APPLICATION FOR CERTIFICATION FOR THE PUENTE POWER PROJECT Docket No. 15-AFC-01

SUPPLEMENTAL INFORMATION REGARDING TRANSMISSION SYSTEM ENGINEERING

Michael J. Carroll LATHAM & WATKINS LLP Counsel to Applicant Puente Power Project (15-AFC-1) Simple Cycle Project Electrical Equipment Ratings

As requested, preliminary breaker and bus ratings not previously shown have been added for the electrical equipment on the Key Single Line Diagram 31380-P029-MAN-SK 2. The ratings added are as follows:

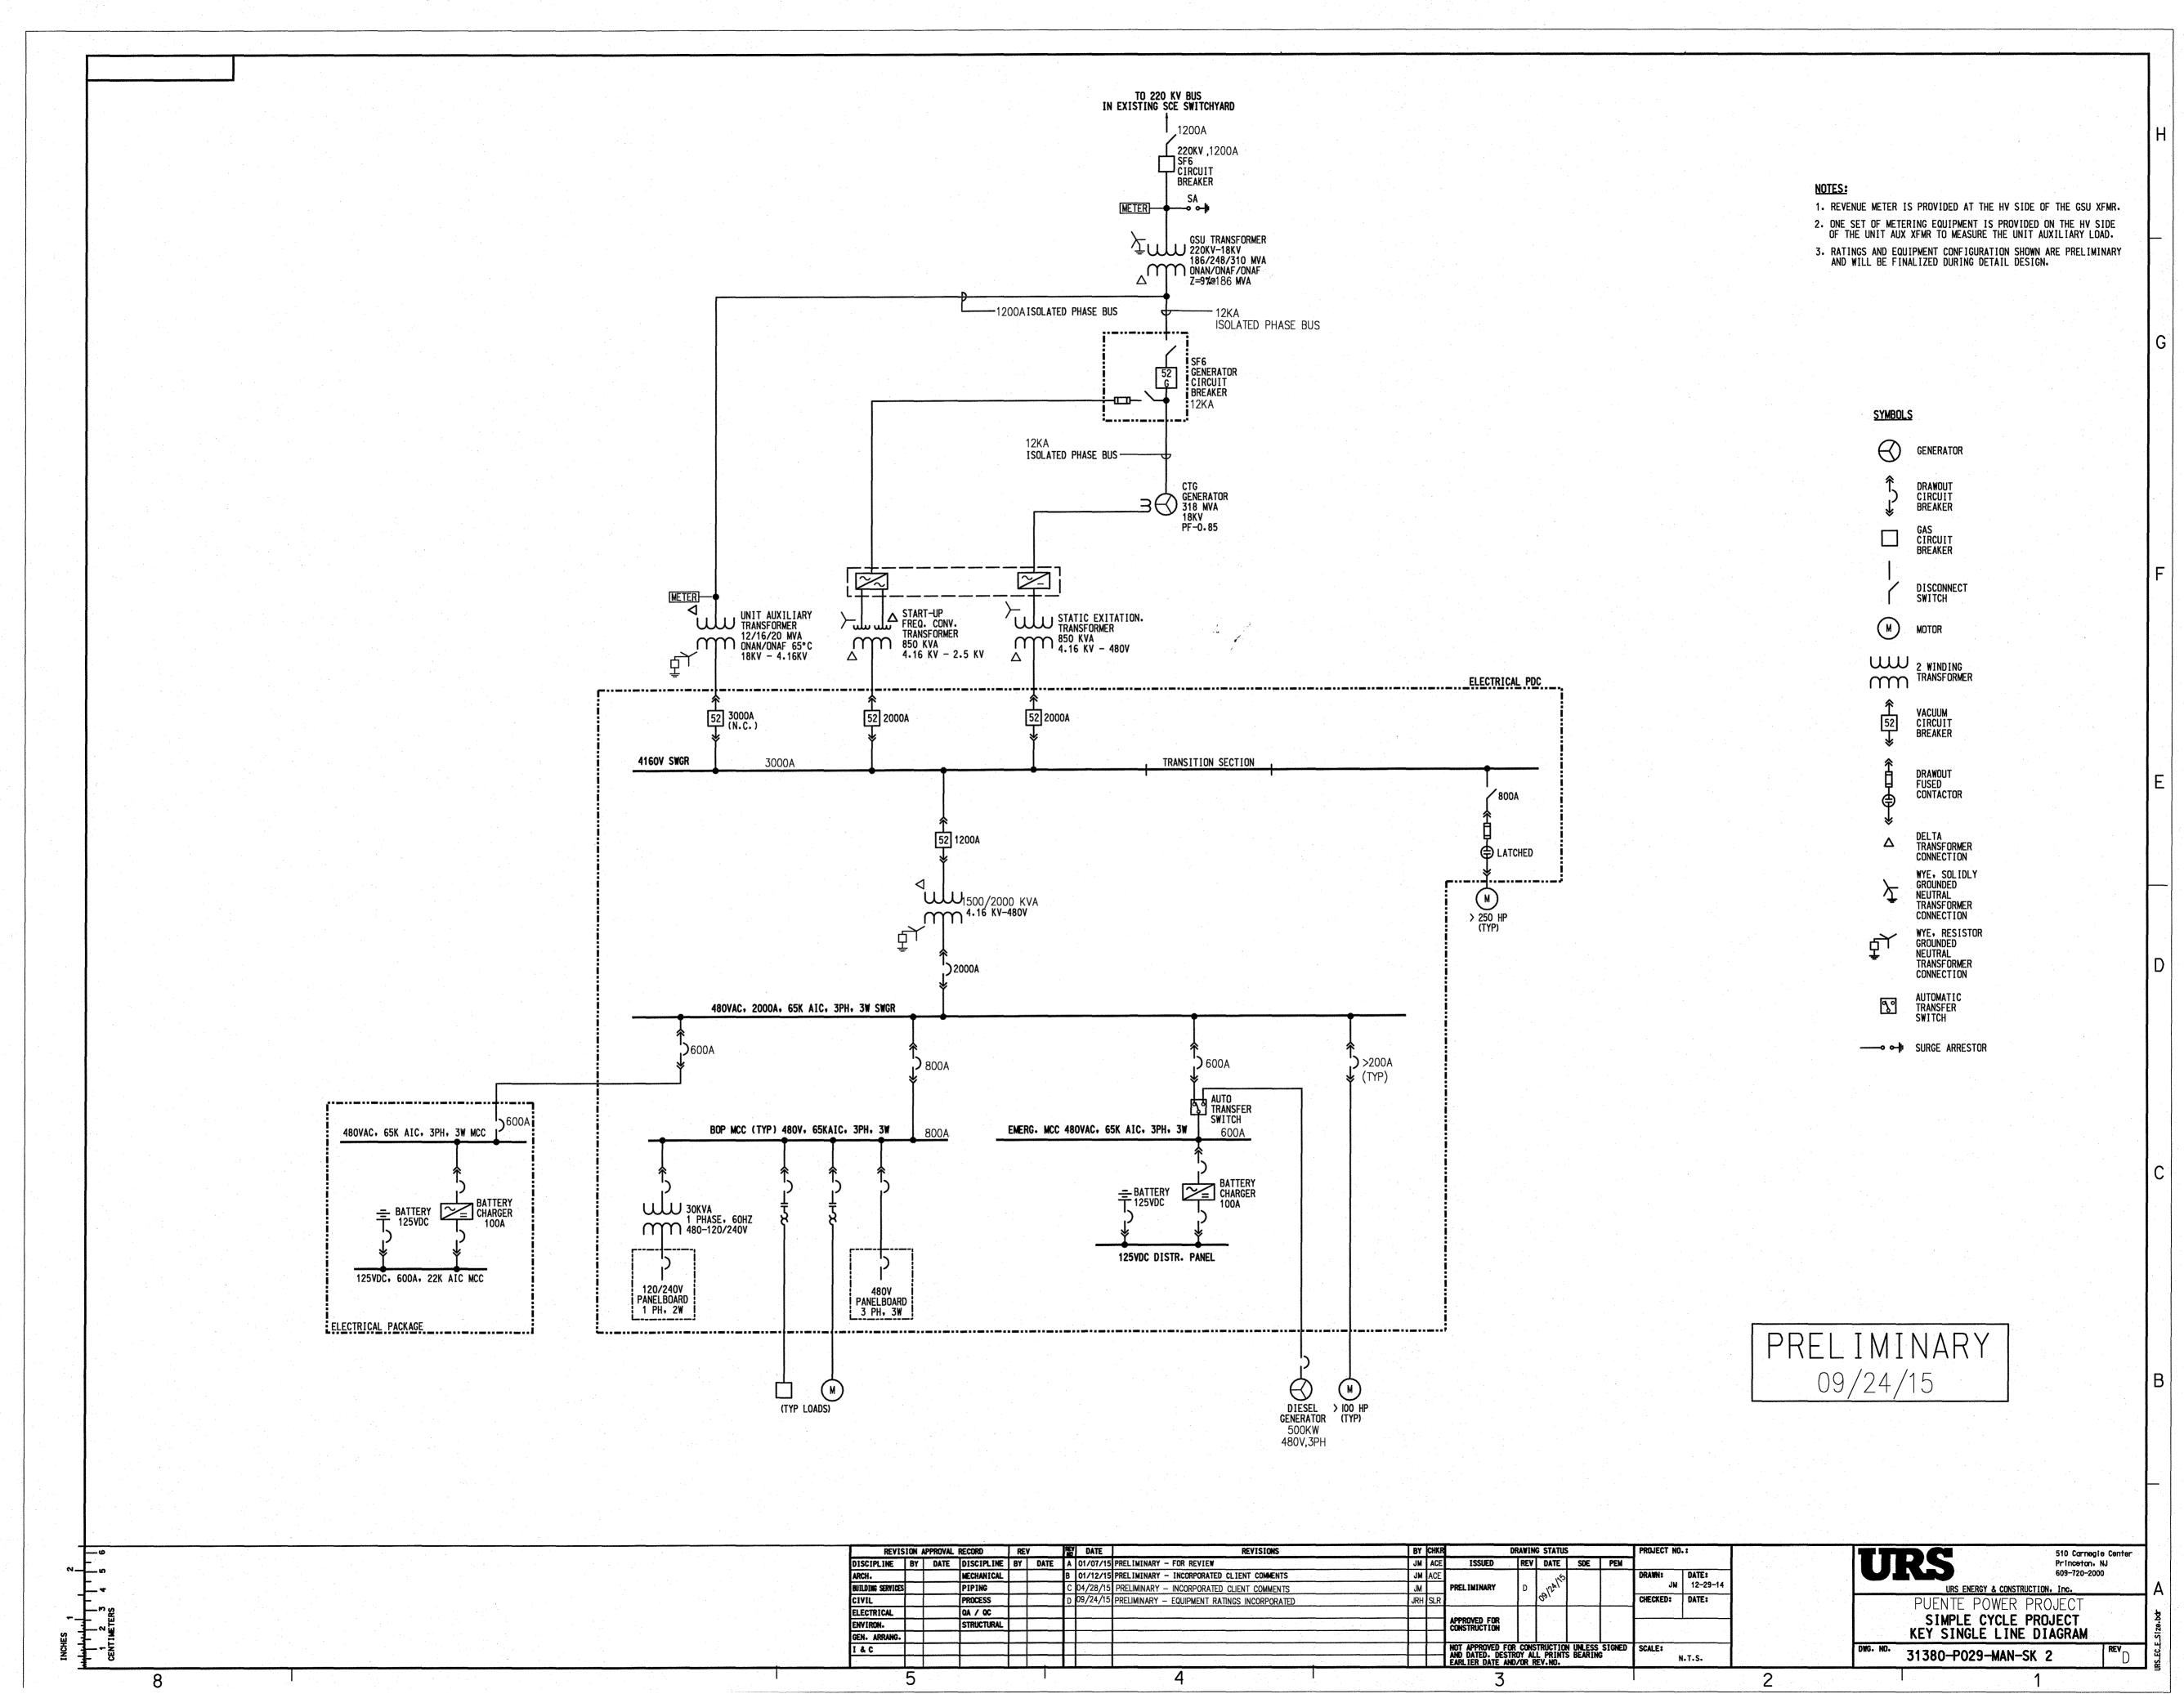
- 220kV disconnect switch The continuous current rating of 1200A was added. This is the next higher standard disconnect switch size above the maximum output capability of the GSU transformer at 220kV.

- 220kV breaker The continuous current rating of 1200A was added. This is the next higher standard breaker size above the maximum output capability of the GSU transformer. The breaker interrupting rating will probably be 63kAIC but is not shown since insufficient information from the utility is available at this time to determine that rating.

- Isolated phase bus duct The main bus duct run from the GSU transformer to the generator breaker and from the generator breaker to the generator is sized for a continuous current of 12kA. This is the next higher standard rating for selfcooled isolated phase bus above the maximum generator output current level at the generator minimum voltage (17.1kV). The isolated phase bus duct tap bus from the main bus to the auxiliary transformer is rated at 1200A continuous current. This is the next higher standard self-cooled rating above the maximum auxiliary transformer rating.

- Generator breaker and disconnect switch The generator breaker and disconnect package is rated at 12kA continuous current which is the next larger standard size above the rated generator output level at minimum generator voltage. The fused disconnect shown from this equipment to the starting frequency conversion equipment is for control purposes only. Interrupting rating for the generator breaker is not shown since dependent upon the manufacturer of this equipment. Calculations indicate the interrupting rating required would be 65kAIC or greater based upon the maximum let through current for a 9% @ 186MVA impedance in the GSU transformer and an assumed x"_d of 0.2 for the generator.

- 480V switchgear motor feeder breaker The typical motor feeder breaker from the 480V switchgear would be a nominal 800A frame size with trip device selected to protect the motor. Typical motor sizes of 100HP and higher would require breaker trip settings typically in the range of 200A or higher. The actual trip device setting would be dependent upon the switchgear vendor selected and set based upon National Electrical Code (NEC) requirements. Interrupting ratings for all switchgear breakers are 65kAIC as indicated on the 480V bus.

- 480V Electrical Package MCC main breaker The MCC main breaker will have the same current rating as the feeder breaker in the 480V switchgear. Interrupting rating for the MCC main breaker is 65kAIC as indicated on the 480V MCC bus.
